Lee Nuclear Station Units 1 and 2

Evaluation of 2012 Field Investigation Results for Plant Relocation

Comparison of Plant Relocation and
COLA P-S Suspension Compressive and
Shear Wave Velocity Results - Unit 1
FIGURE 17

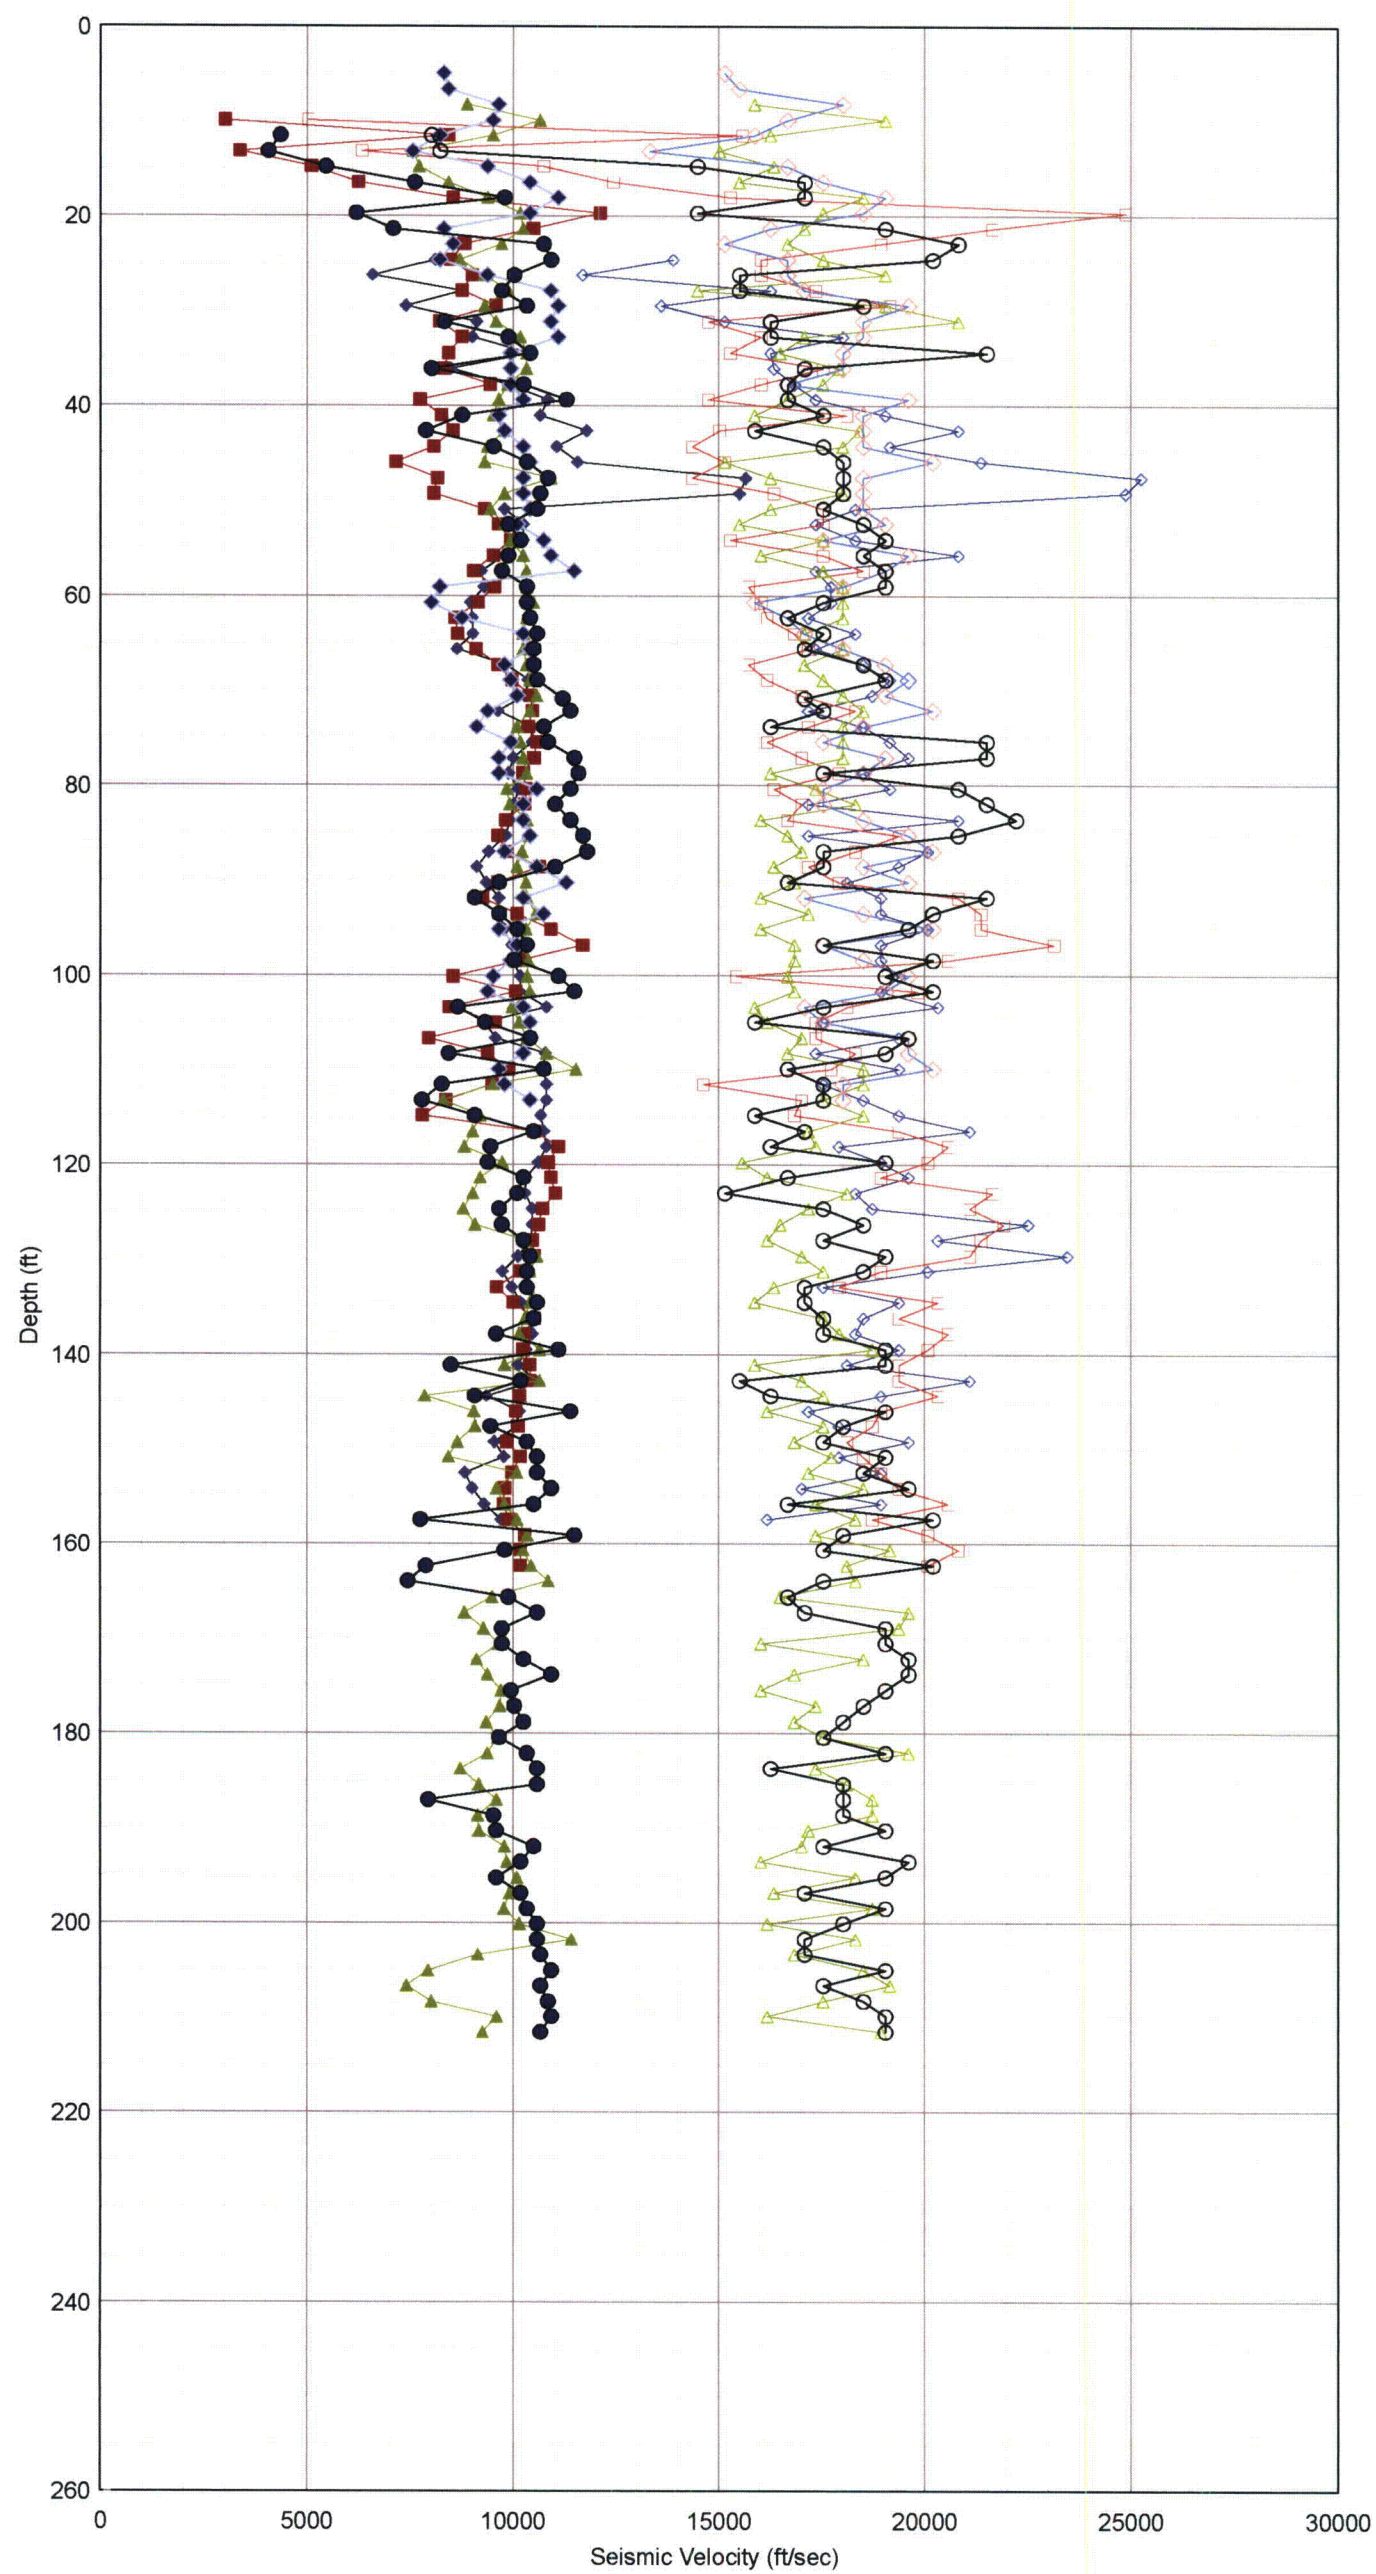
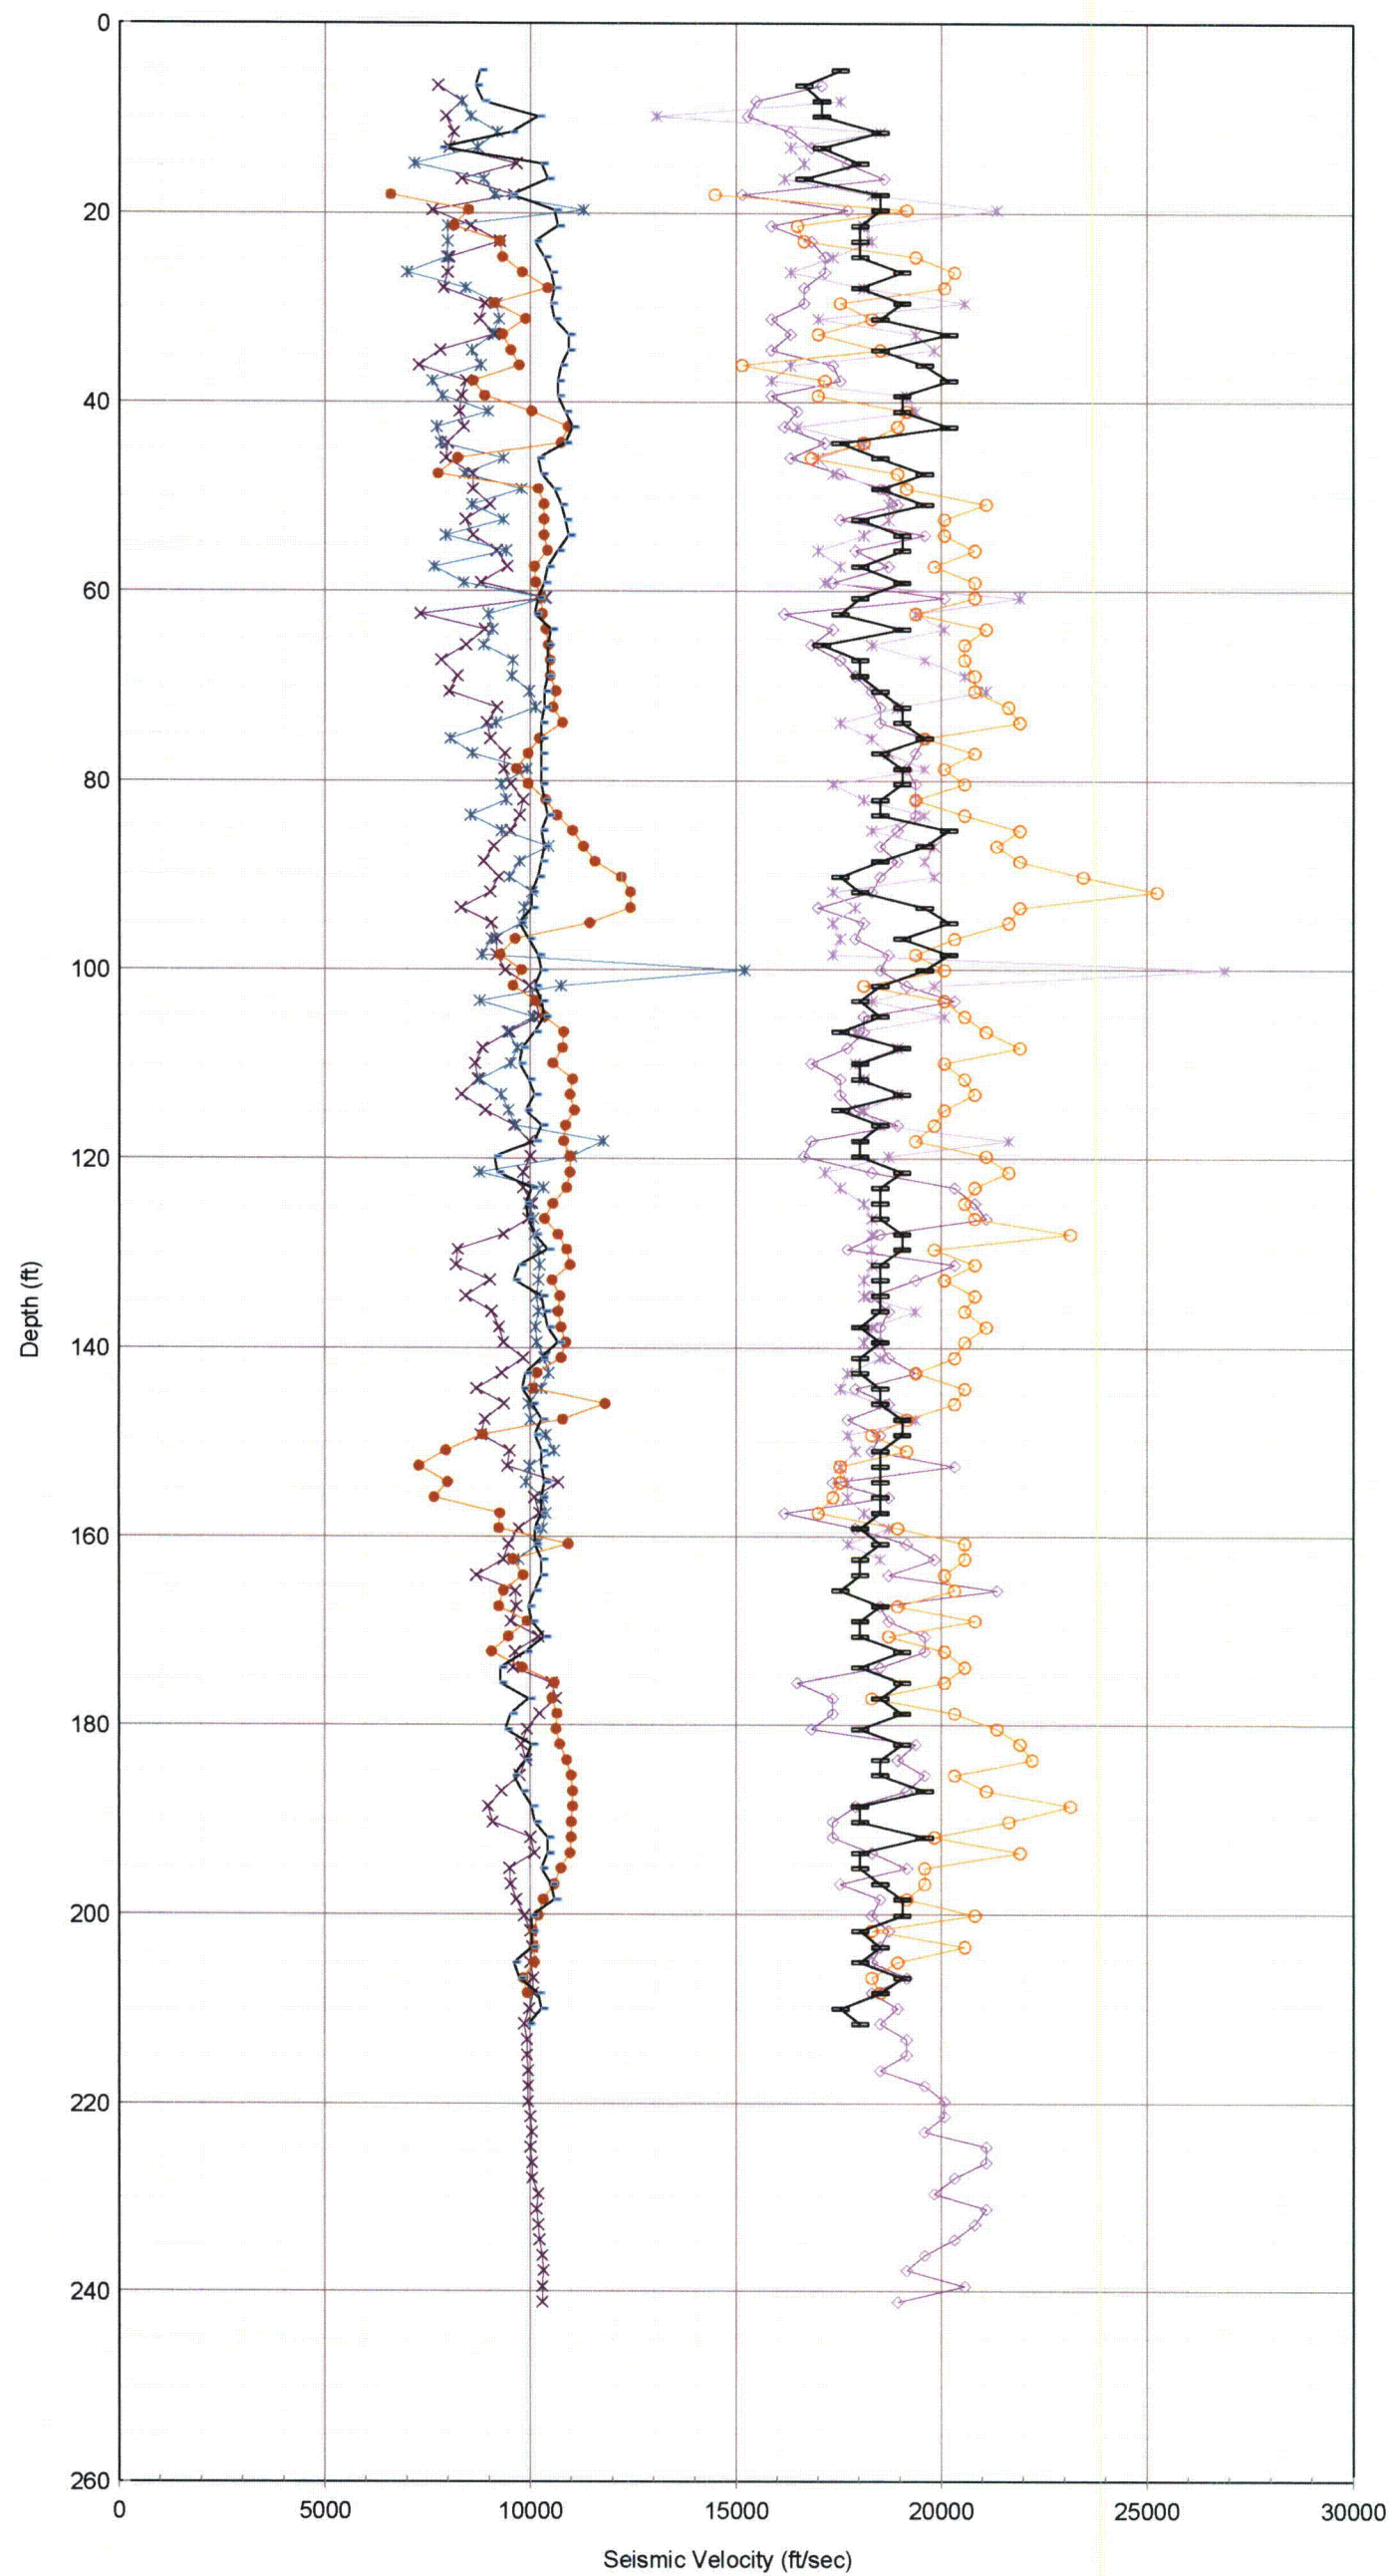
In Figure 17, the seismic wave velocities from P-S Suspension data for the relocated Unit 1 nuclear island 2012 borings B-2000 and B-2002 is compared to the results from 2006-2007 logs. Inspection of this figure shows the 2012 shear wave (V_s) and compression wave (V_p) data are consistent with previous results and show good correlation to the COLA data in FSAR Revision 6.

The comparisons described above show that the V_s and V_p data at WLS Unit 1 from the 2012 borings is consistent with the 2006-2007 borings; thus the dynamic profile (Base Case A1 – Unit 1, FSAR Figure 2.5.4-252 Rev. 6) for the Unit 1 relocated nuclear island is valid for the relocated plant. Note that the revised FIRS A1 – Unit 1 dynamic profile has 3 ft. thickness of fill concrete added to the top of the profile due to the raised plant elevation and is shown in Figure 19. The local velocity profile B (FSAR Figure 2.5.4-249 Rev. 6) at the northwest corner of WLS Unit 1, before relocation, does not exist at the northwest corner of the relocated WLS Unit 1 and therefore is not considered as part of this evaluation.

WILLIAM STATES LEE III
NUCLEAR STATION UNITS 1 & 2
Schematic Comparison of August 2012
to Pre-August 2012 Dynamic Profile -
Base Case A1 at Unit 1 Nuclear Island
FIGURE 19

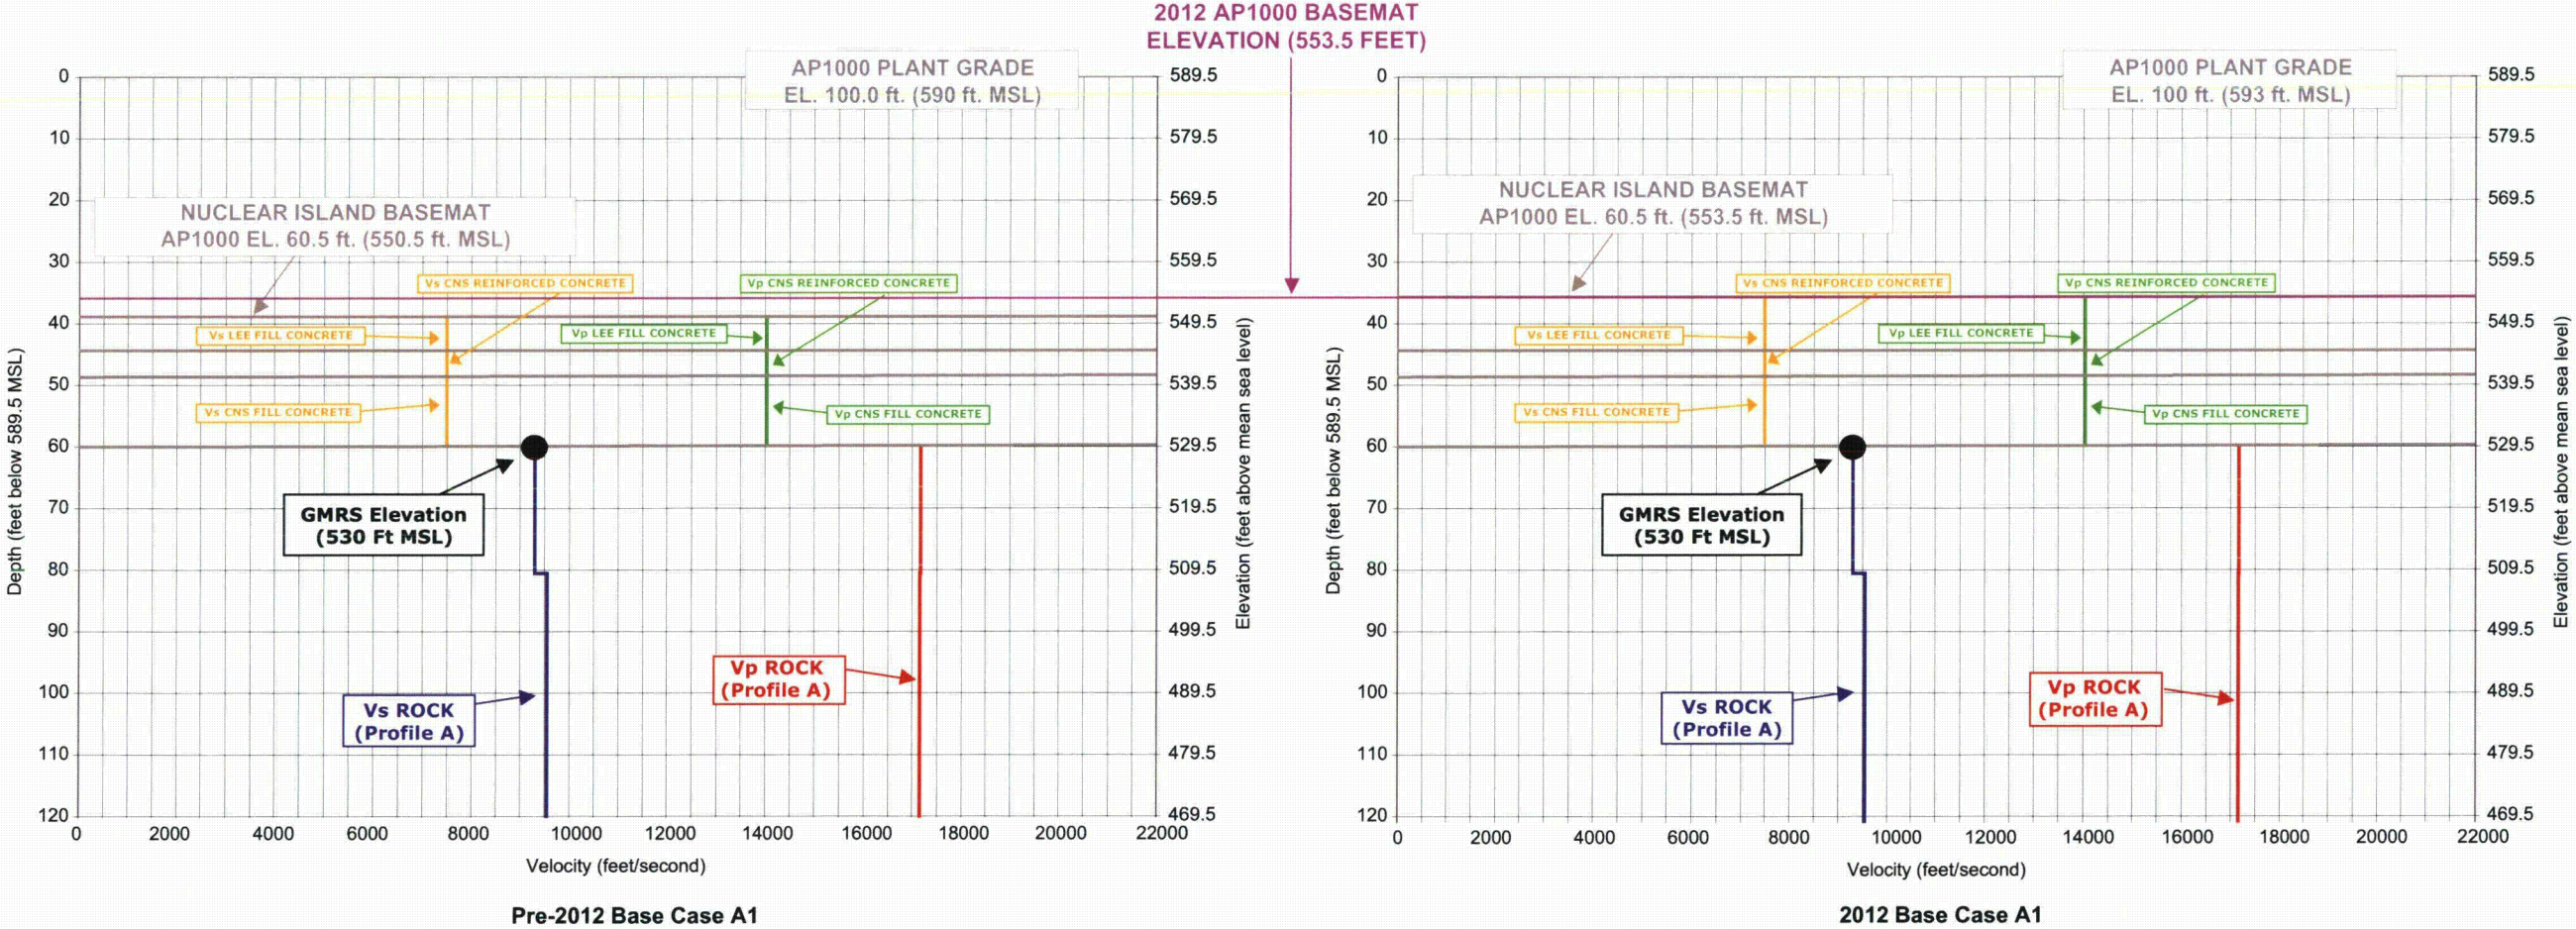
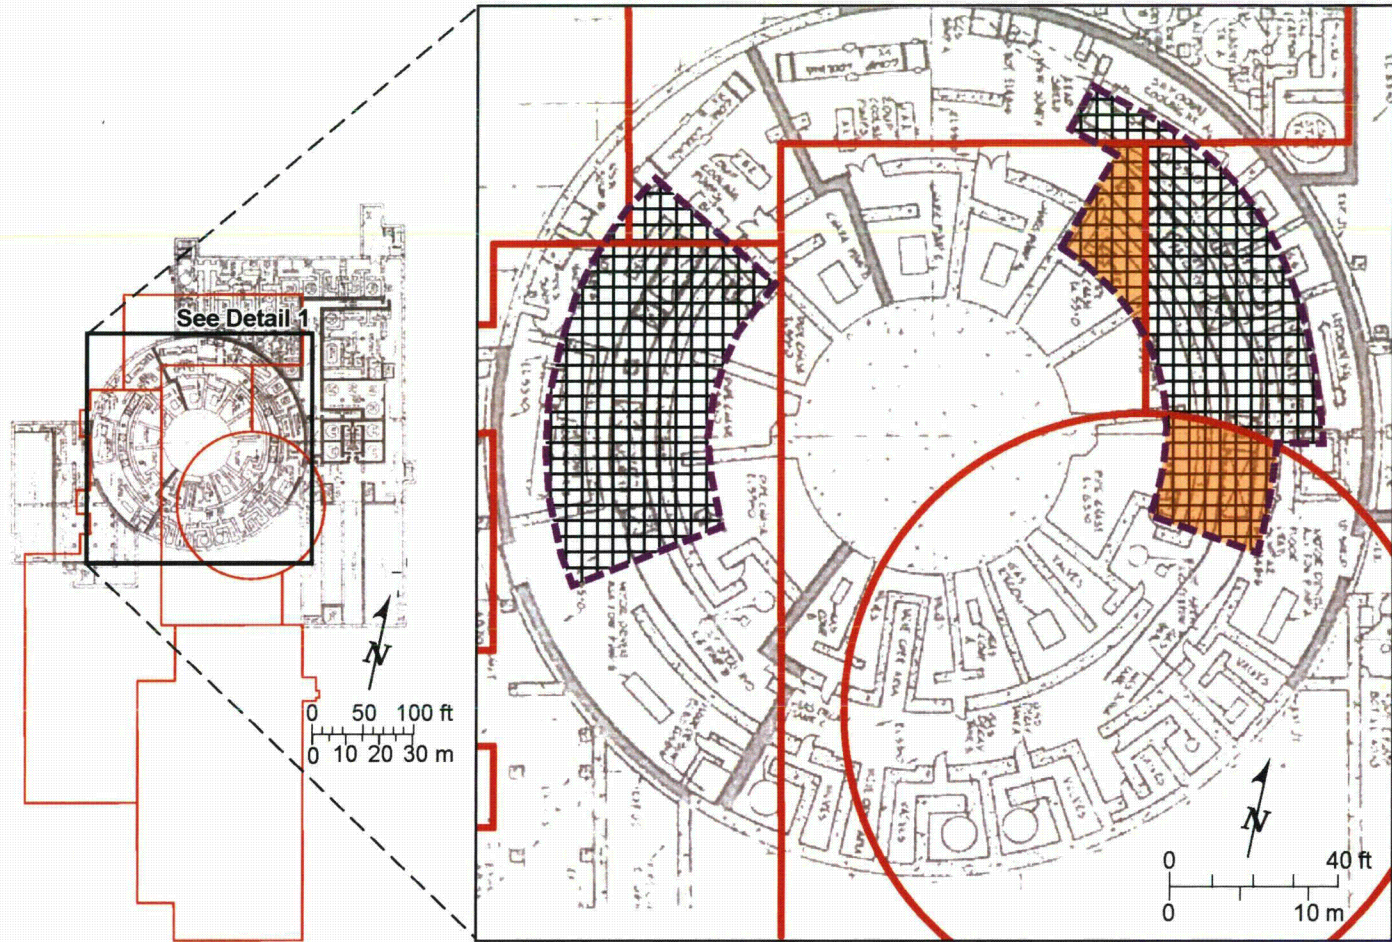
Suspension results to COLA (FSAR Revision 6) testing results. Figure 19 illustrates the small increase in concrete fill thickness for the 2012 to pre-2012 Dynamic Profile - Base Case A1.

Change in the shear wave velocity profile attributed to the increased concrete fill thickness (3 ft.) at the hard rock condition results in a negligible variation in site response calculations for relocated Unit 1. The additional thickness of fill concrete amounts to a 15% increase in the fill concrete profile for relocated FIRS A1 for the relocated Lee Nuclear Station Unit 1 nuclear island. The average shear wave velocity of the shear wave velocity profile with the added concrete is slightly different from the average shear wave velocity of the profile before the addition of the 3 ft. of fill concrete. This small change will have no practical significance on differential shear wave velocity, site amplification or foundation performance and compliance with the subsurface uniformity criteria as described in AP1000 DCD Subsection 2.5.4.5.
